Access Compliance Report

Public Rights-of-Way

Intersection ID: 5781	Main Street: NEAL_RD	Cross Street: IBM_DR	Location: S
ADA ID: 22CFE1535463	Ramp Type: PerpDiag	Initial Pass/Fail: Fail	Overall Compliance: No
		Severity Score: 10

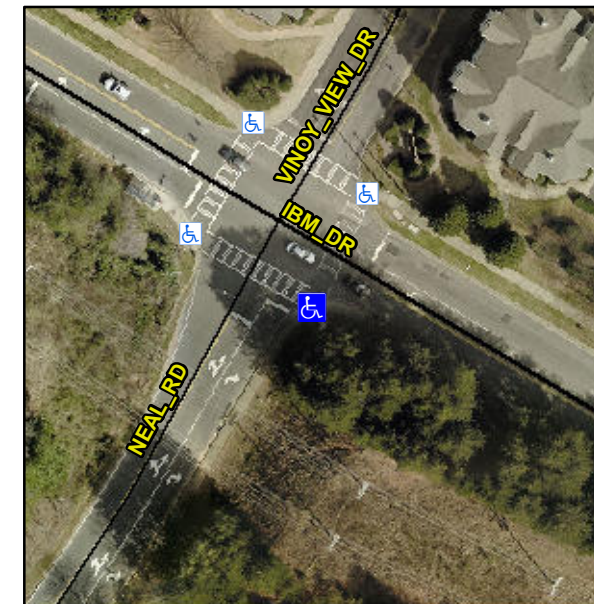
Not Found, R304.5.1, R304.5.3

Compliance	Description	Data	Compliance	Description	Data
N/A	Ramp Length (in)	70.0	Yes	Ramp Slope (%)	7.7
No	Ramp Width (in)	47.5	No	Ramp XSlope (%)	2.9
N/A	Flare Type LT	N/A	N/A	Flare Type RT	N/A
N/A	Flare Slope LT (%)	N/A	N/A	Flare Slope RT (%)	N/A
N/A	Flare Traversable LT?	N/A	N/A	Flare Traversable RT?	N/A
N/A	Landing Length (in)	N/A	N/A	DWS Provided?	N/A
N/A	Landing Width (in)	N/A	N/A	DWS Contrast?	N/A
N/A	Landing Slope (%)	N/A	N/A	DWS Length (in)	N/A
N/A	Landing X Slope (%)	N/A	N/A	DWS Full Width?	N/A
N/A	Landing Curb? (Y/N)	N/A	N/A	DWS Offset (in)	N/A
N/A	Shared Landing?	N/A			
N/A	Gutter Ponding?	N/A	N/A	Gutter Slope (%)	N/A
N/A	Gutter Lip Ht (in)	0.5	N/A	Gutter X Slope (%)	N/A
N/A	Painted X Walk1?	Yes	N/A	Painted X Walk2?	Yes
	X Walk 1 Direction	To NE		X Walk 2 Direction	To NW
N/A	X Walk 1 Width (in)	111.0	N/A	X Walk 2 Width (in)	116.0
	X Walk 1 Slope (%)	1.6		X Walk 2 Slope (%)	1.9
	X Walk 1 X Slope (%)	4.3		X Walk 2 X Slope (%)	1.2

Remove & Replace Curb Ramp With Two New Directional Ramps or Equivalent.
